DEPARTMENT OF THE NAVY
SOUTHWEST DIVISION
NAVAL FACILITIES ENGINEERING COMMAND
ENVIRONMENTAL DIVISION
1220 PACIFIC HIGHWAY, RM 18
SAN DIEGO, CALIFORNIA 92132-5181

M60050.000935
MCAS EL TORO
SSIC # 5090.3

5090
Ser 09E/641
April 27, 1995

Total Dissolved Solids (TDS) Increase Impacts to Water Usage

FIGURE
SIMULATED GROUNDWATER
PATHLINES FROM TCE
PLUME IN PRINCIPAL
AQUIFER AFTER 20 YEARS
ALTERNATIVE 1
MCAS EL TORO
GROUNDWATER MODELING REPORT

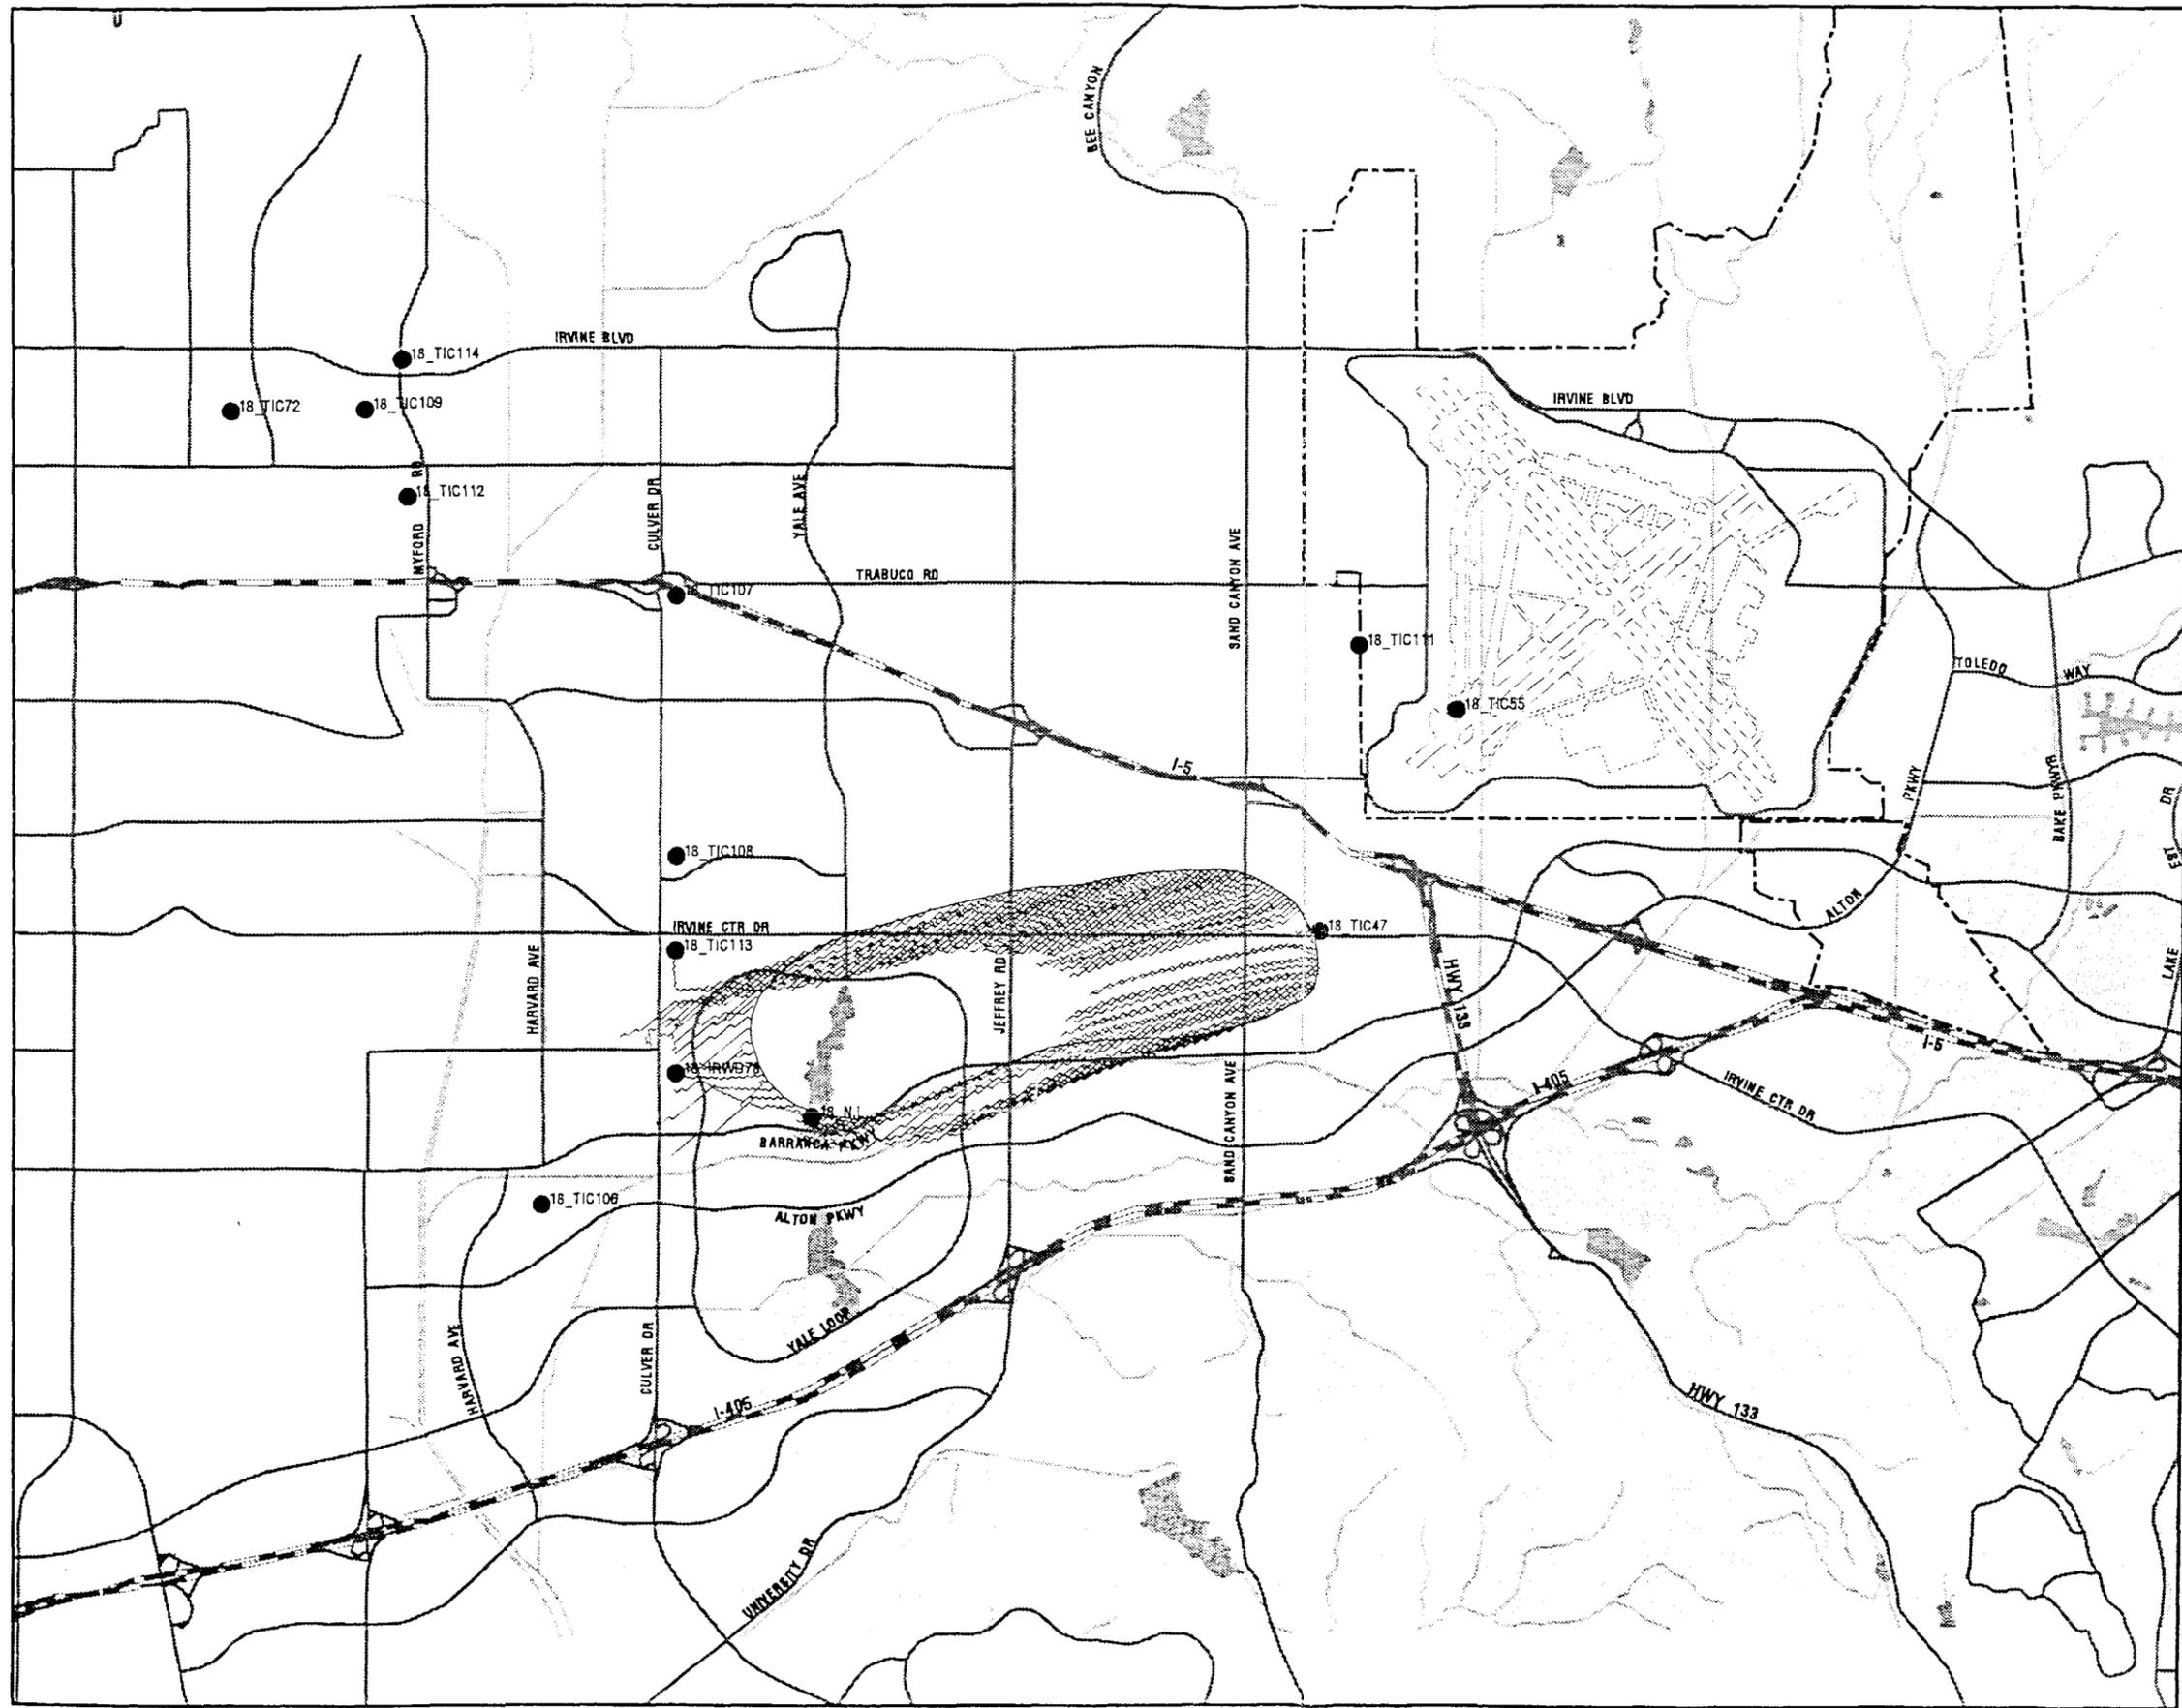
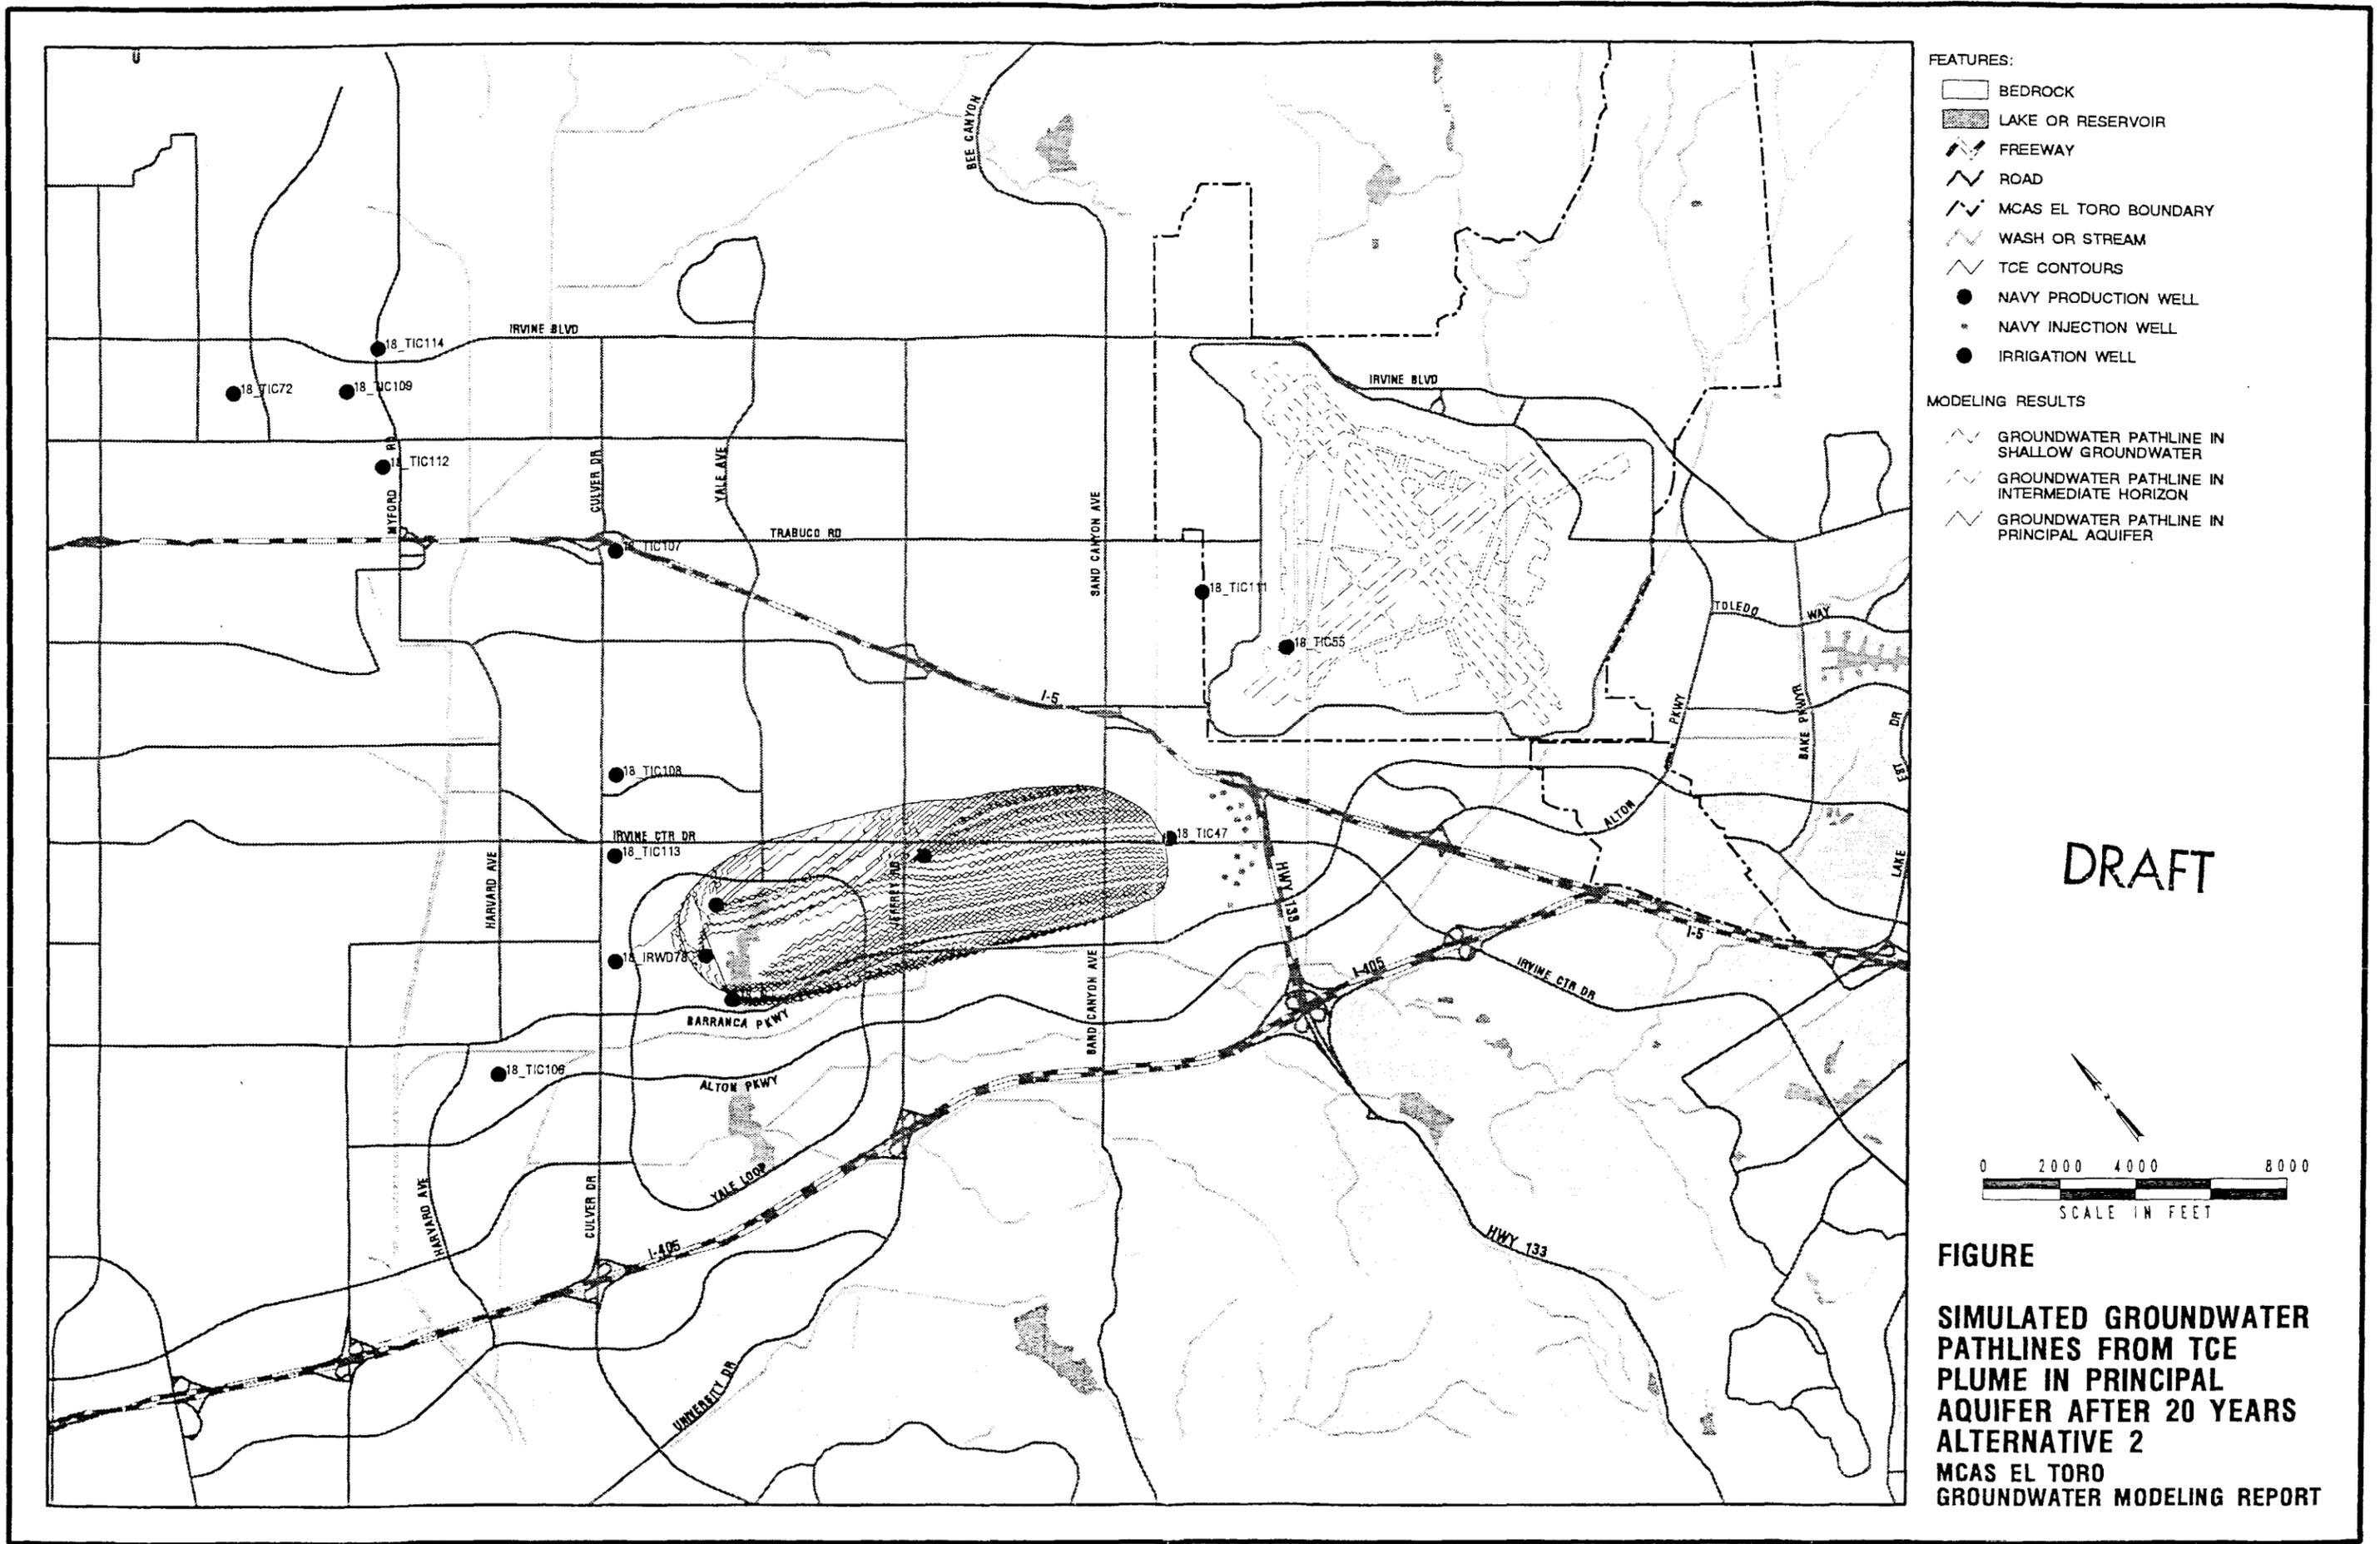
At the April 13 meeting, 20 year simulated TCE plume groundwater pathlines for the shallow groundwater (enclosure 1) and principal aquifer (enclosure 2) were presented. Both sets of figures model Alternative #1 (No Action), Alternative #2 (Independent DON stand-alone system), and Alternative #3 (Irvine Desalter Project). Although the simulations are for TCE particle tracking, TDS particle tracking would be similar. Even though both Alternative #2 and #3 are improvements over the No-Action scenario, the modeling clearly indicates that Alternative #2 controls particle migration much better than
